State of Michigan
Department of Environment, Great Lakes, and Energy

Site Name: Leelanau Pines Campground
Submission Number: HPR-59MH-CX6Z7
Date: September 11, 2023

PUBLIC NOTICE

Digital EGLE/USACE Joint Permit Application (JPA) for Inland Lakes and Streams, Great Lakes, Wetlands, Floodplains, Dams, Environmental Areas, High Risk Erosion Areas and Critical Dune Areas

SECTION C-C
SCALE: 1" = 30'
VERT SCALE: 1" = 3'

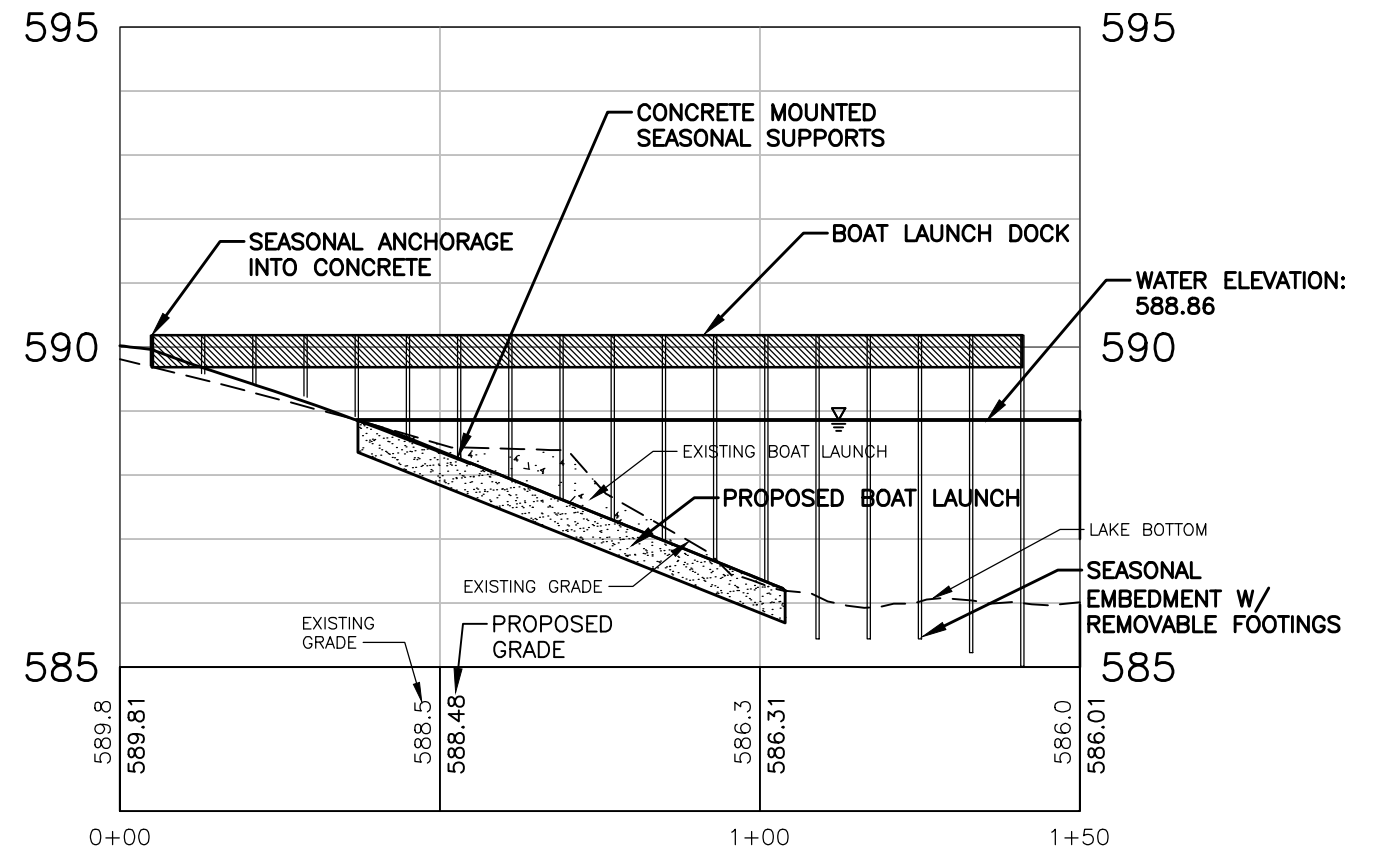
CORRECTION REQUEST (APPROVED)
Boat ramp dock: Based on Sheet 6, section D-D the proposed dock is permanent.

Cross-section D-D, show the proposed fill and excavation for the concrete ramp material.

A concrete ramp is typically recessed into the lakebed; show that work on the project plans.

1 COMMENT
Jason Vander Kodde (jtvanderkodde@ftch.com) (7/20/2023 10:04 PM)
 Figure 6 section D-D has been revised to reflect the seasonal nature of the proposed boat launch dockage. The Structures selection of the USACE JPA remains as previously submitted.

Figure 6 Cross Section D-D has been revised to show the proposed fill and excavation for the concrete ramp material. A table has also been provided on Figure 6 to quantify the associated areas and volumes

7

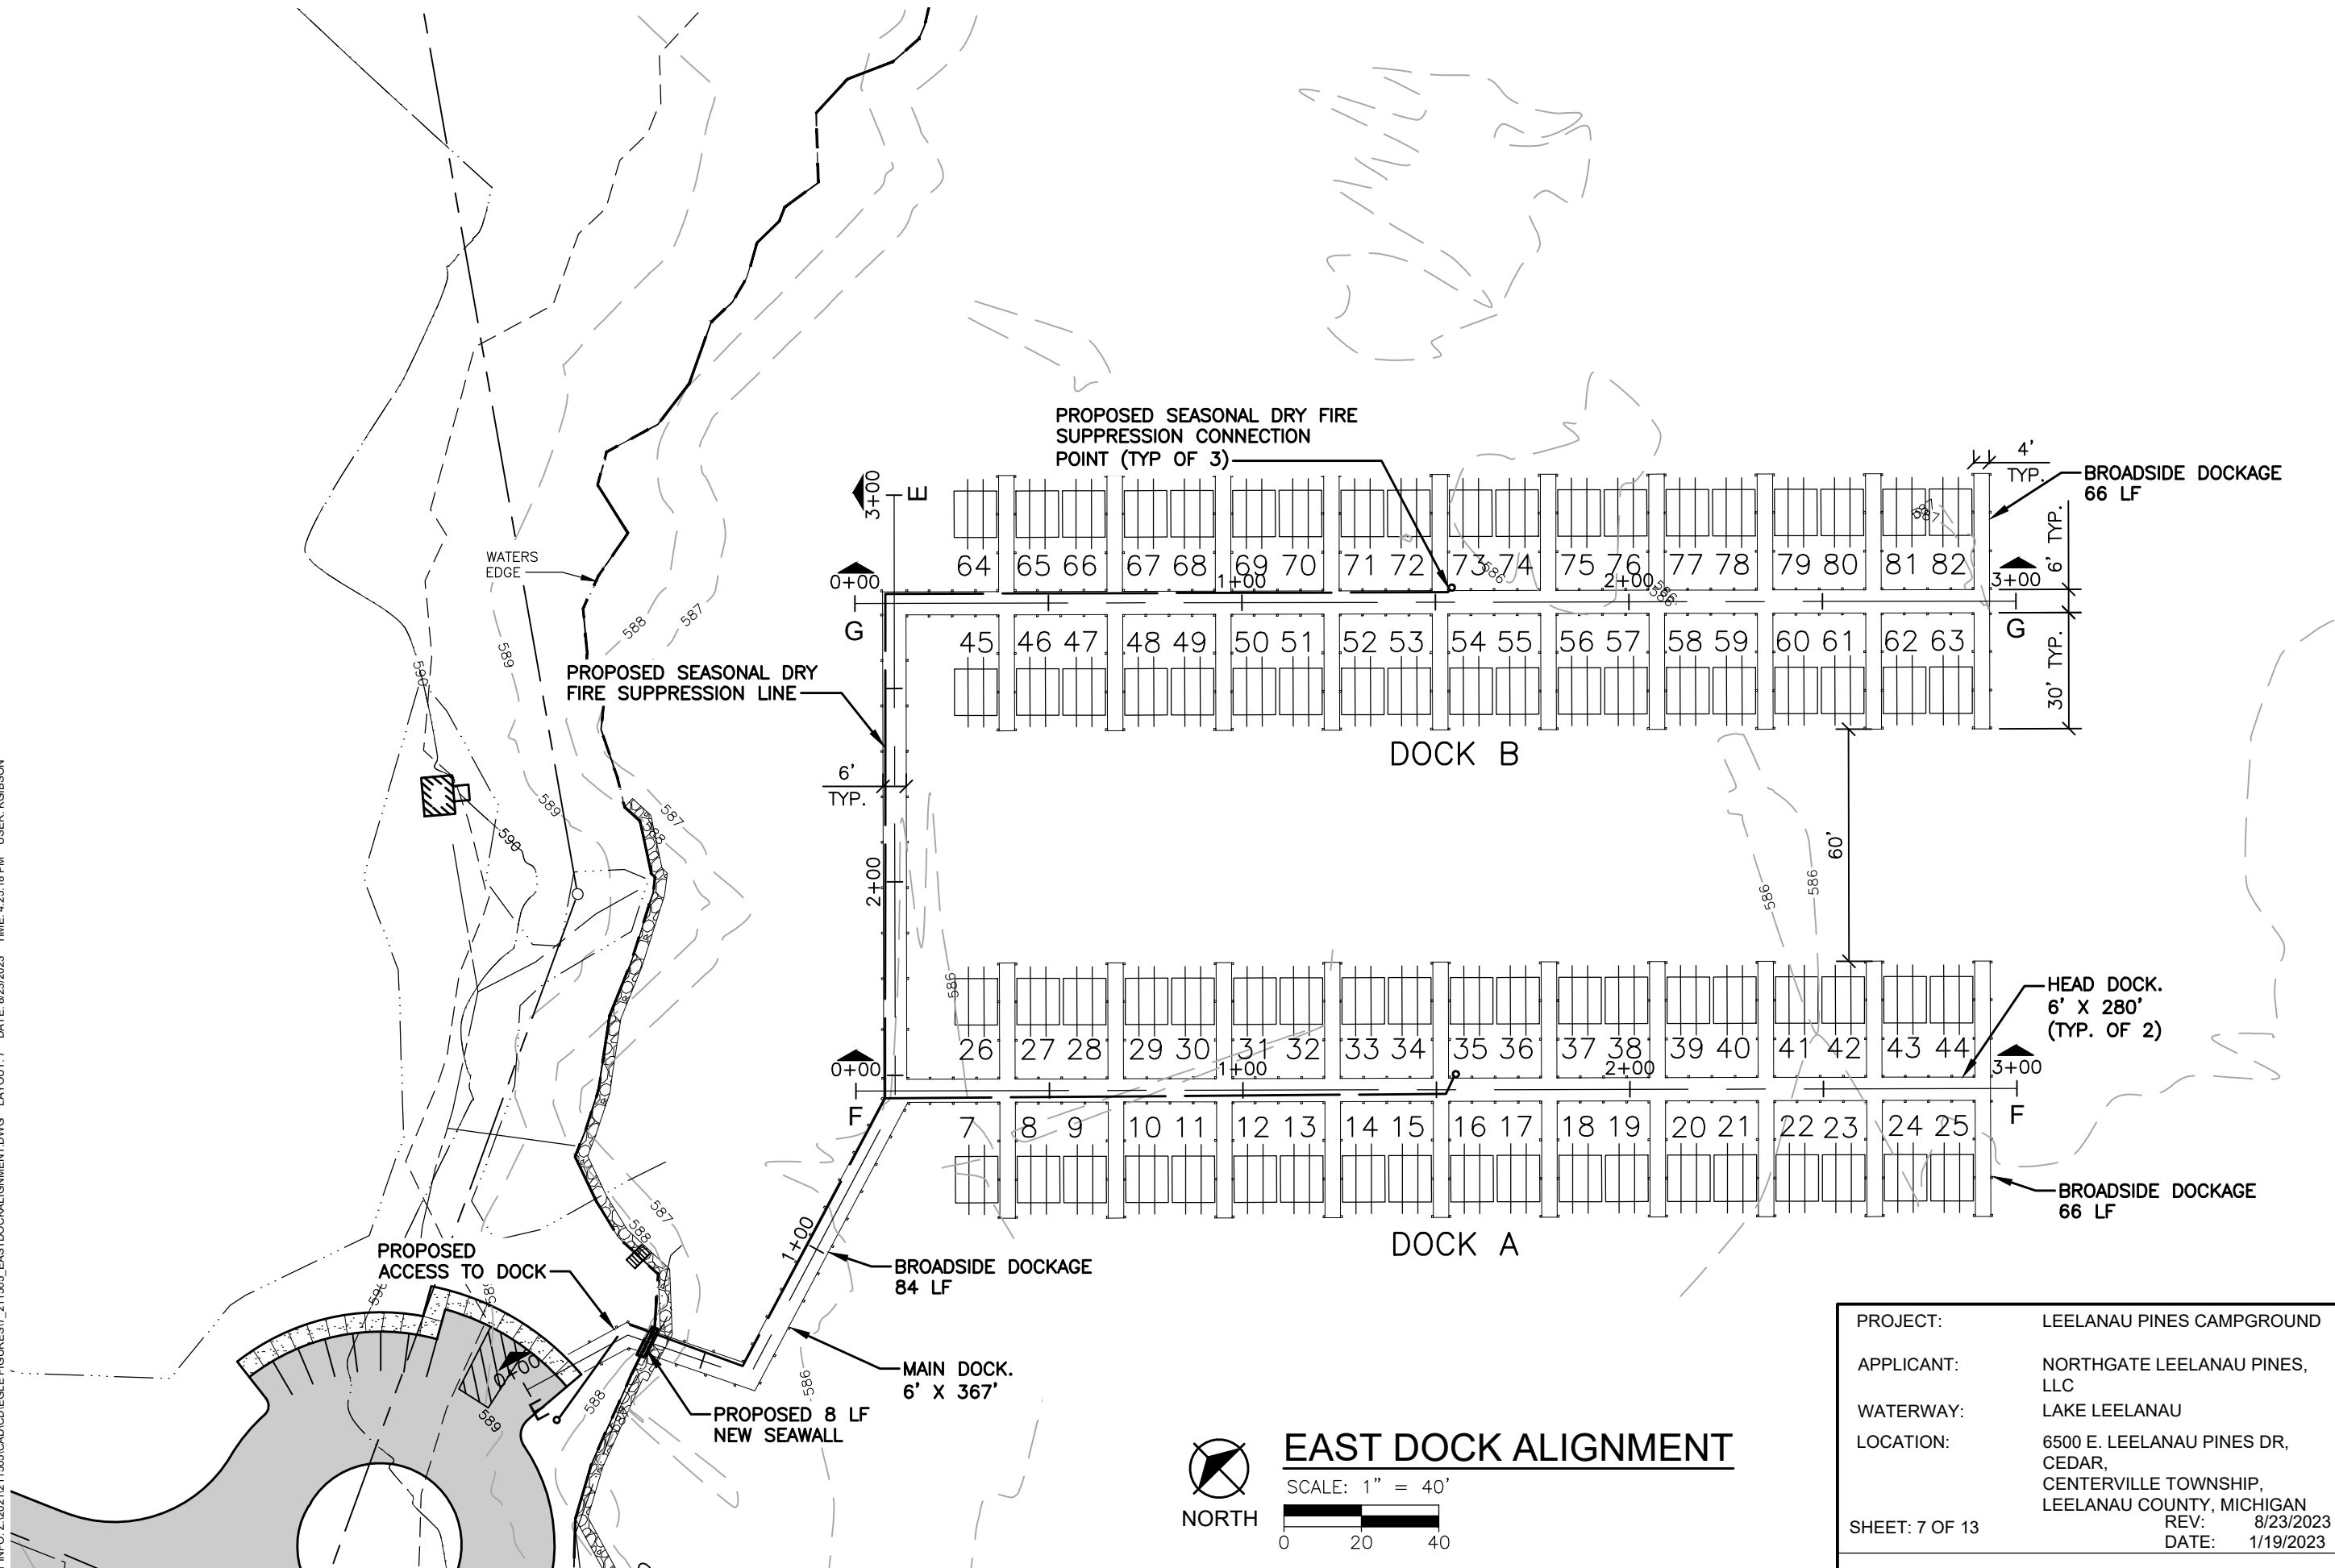
Show the length and width of the finger piers on Sheet 7.

SEAWALL ALIGNMENT

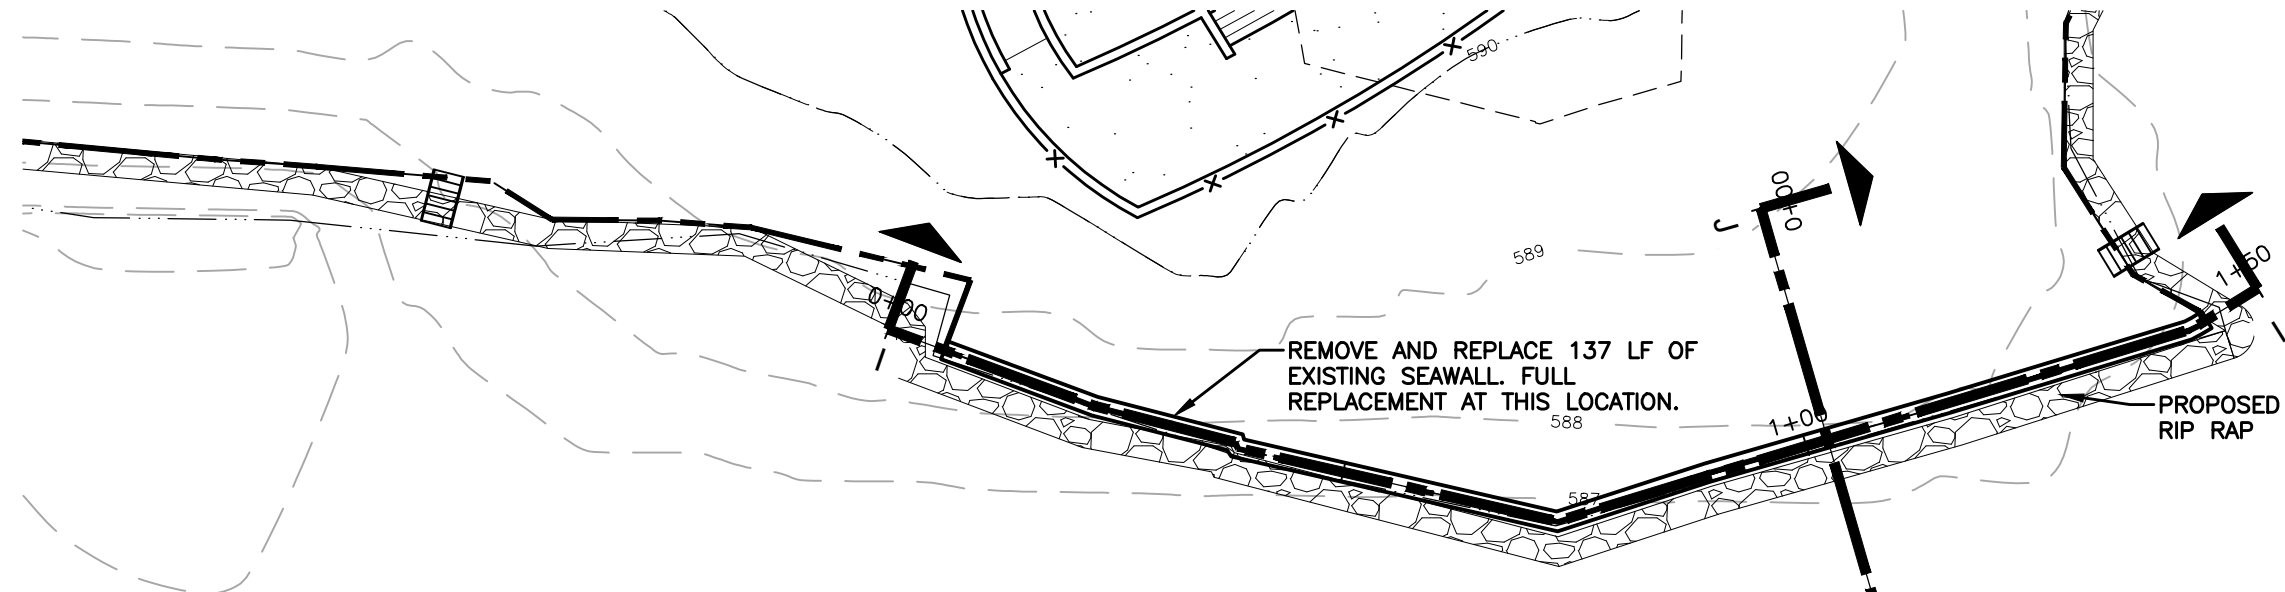
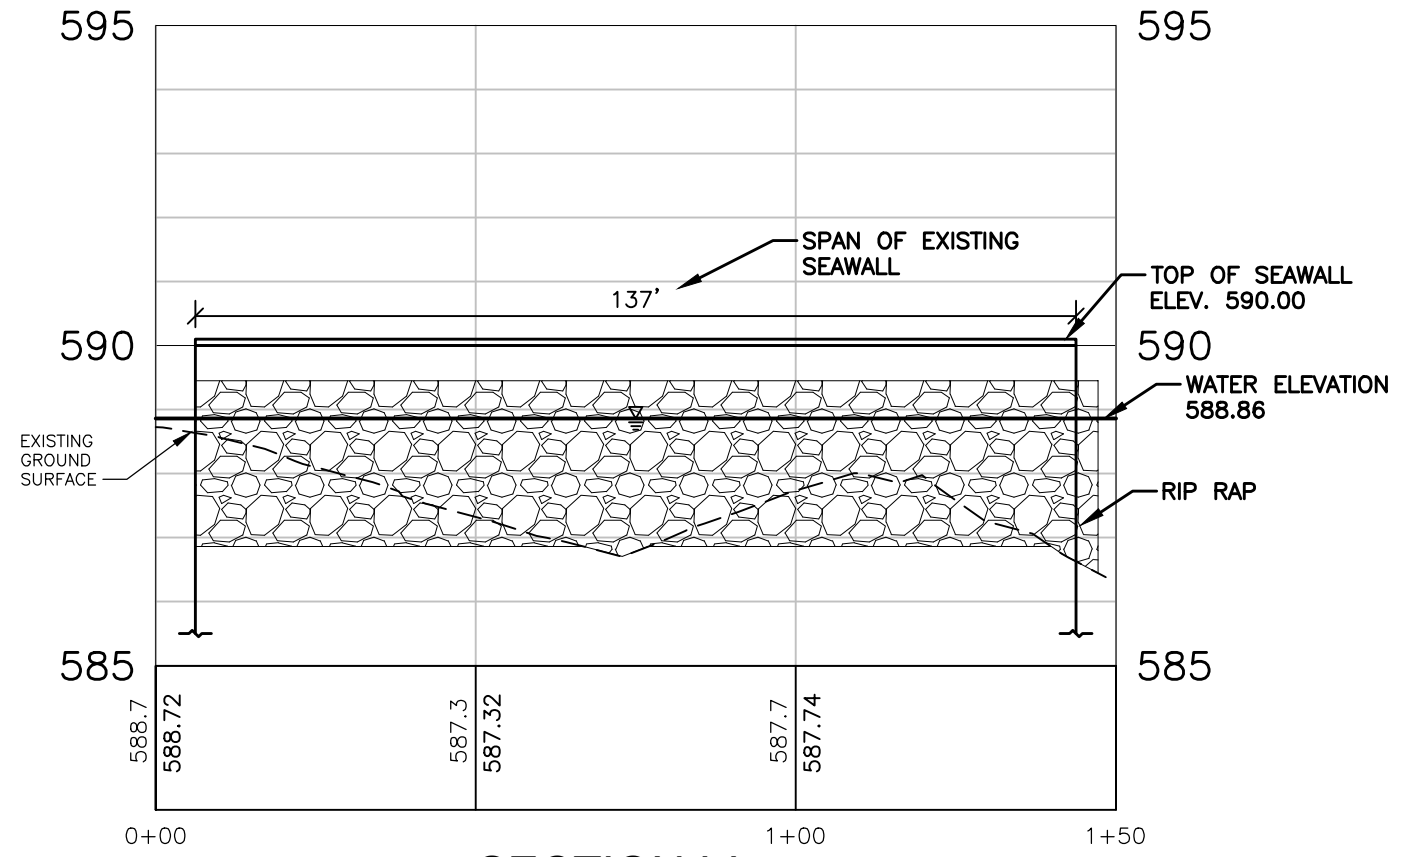
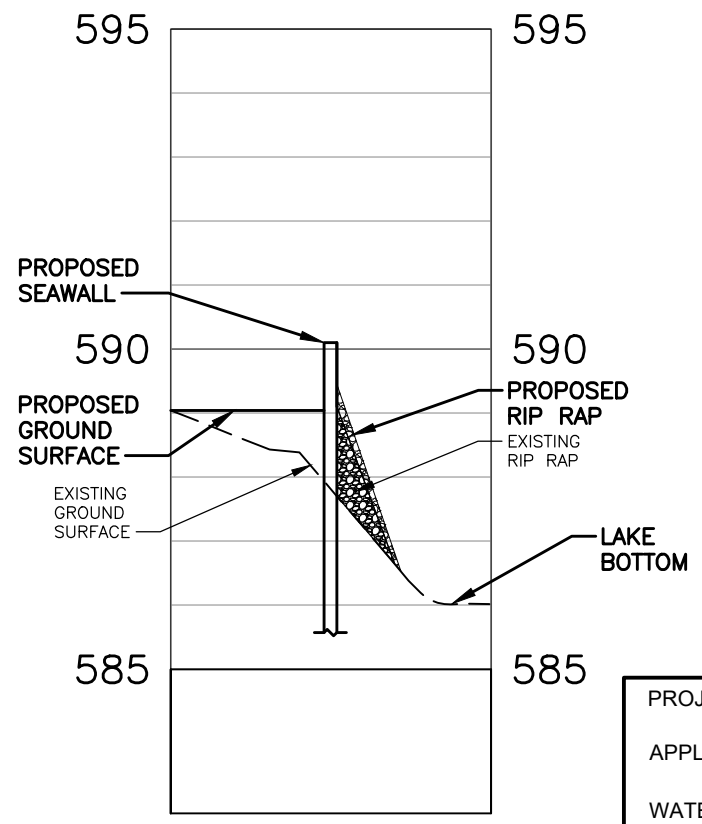
Show detail on the proposed replacement seawall plan; Sheet 10.

Show the distance from the existing seawall to the proposed seawall.

The existing seawall will be removed and replaced with the proposed seawall in the exact same location. There is no distance in between the two locations. The notes on Sheet 10 have been revised accordingly.

TYPICAL STAIR DETAIL
 NOT TO SCALE

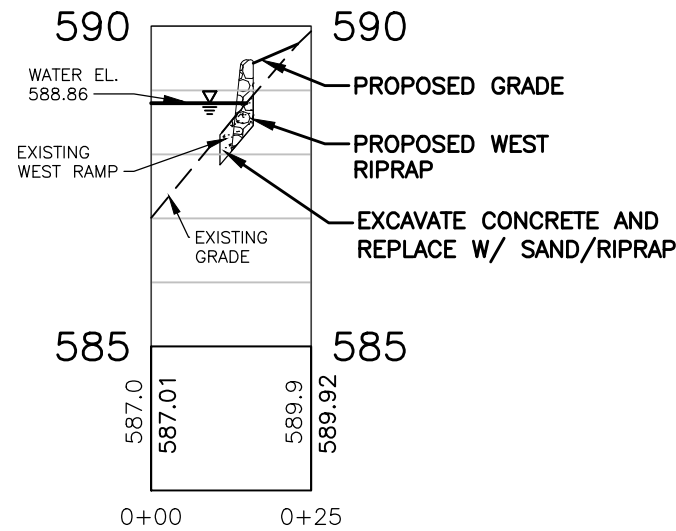
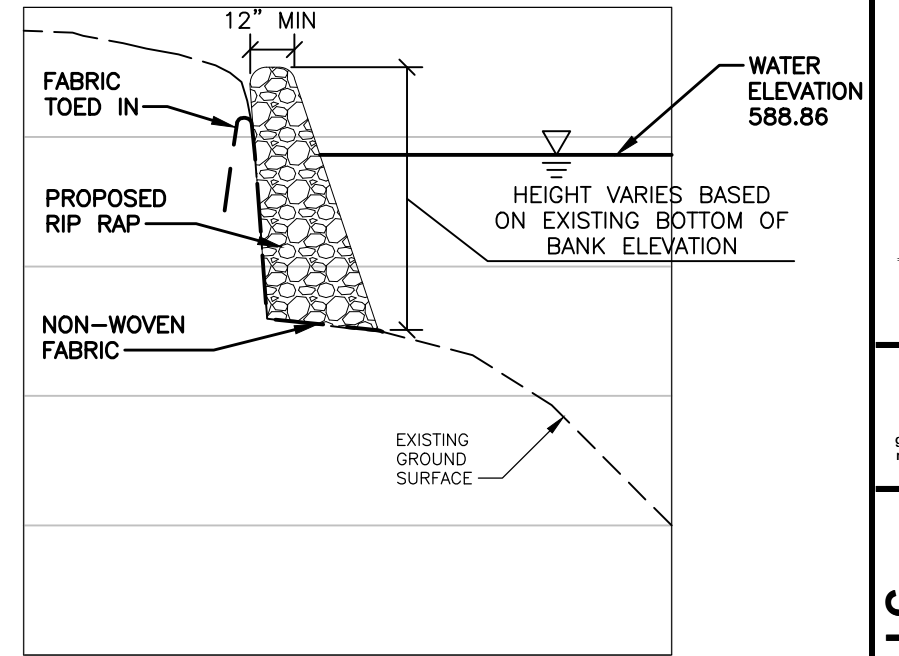
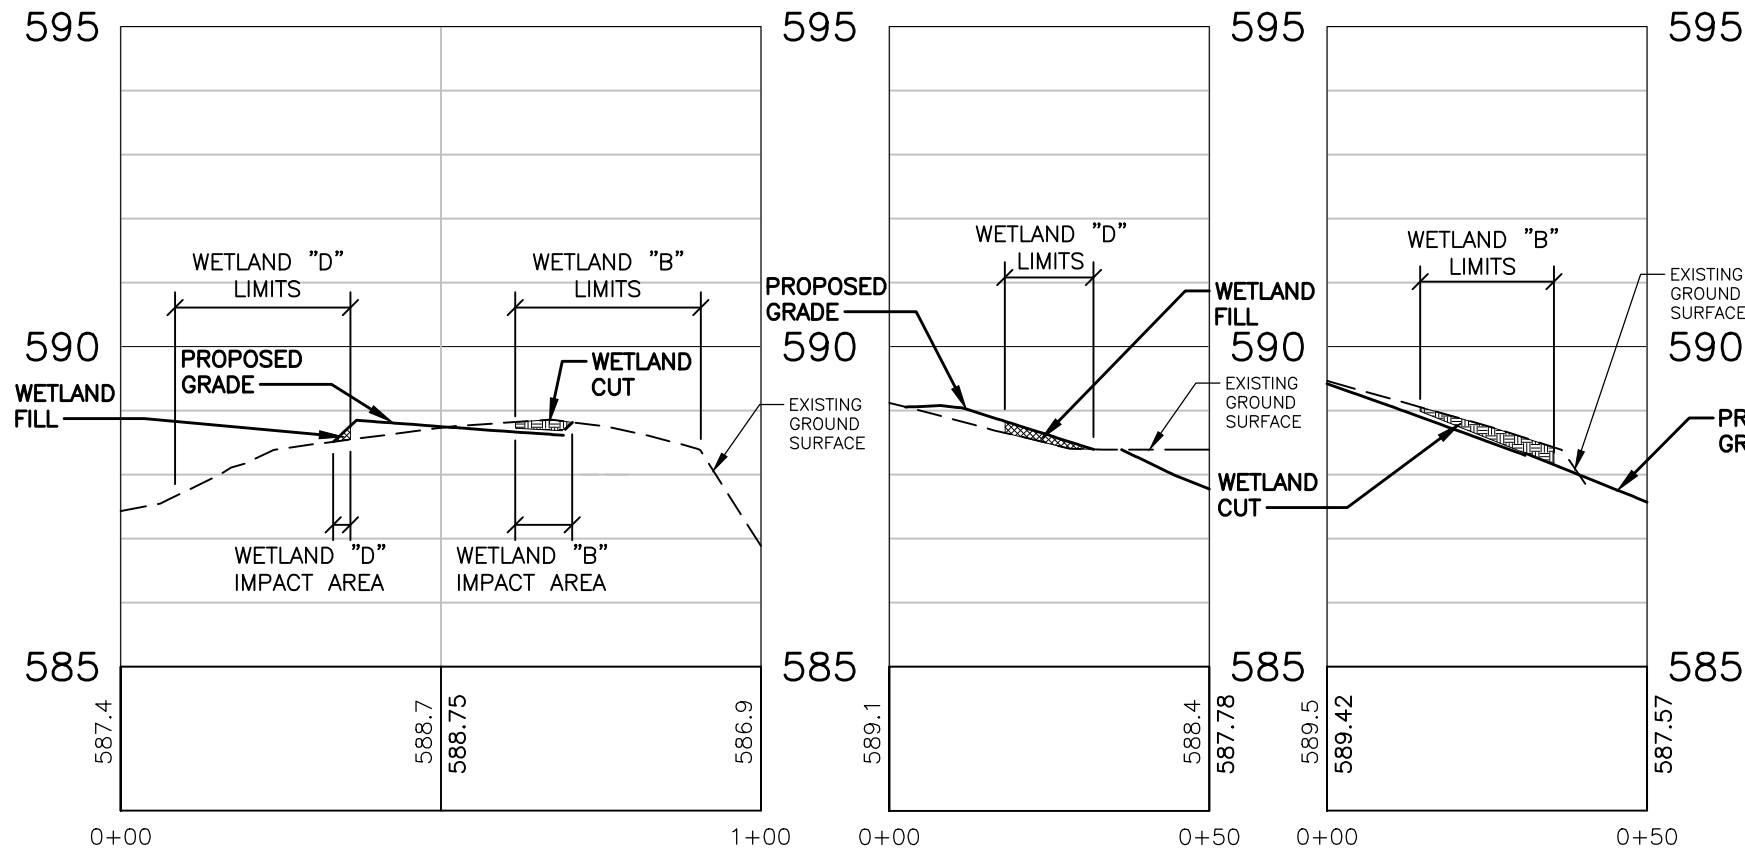
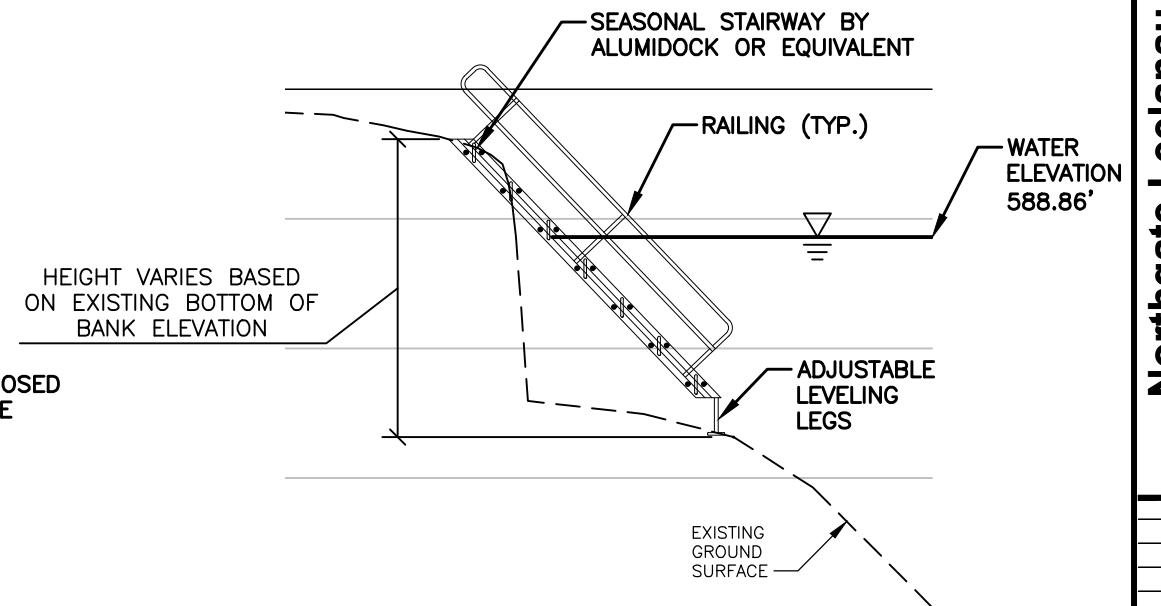
Clarify the cross-section for the proposed stairs on Sheet 12, if they are solid, open pile, seasonal, or...

depending on pricing, options and availability. The typical stair detail on Figure 12 has been revised to clarify this intent.
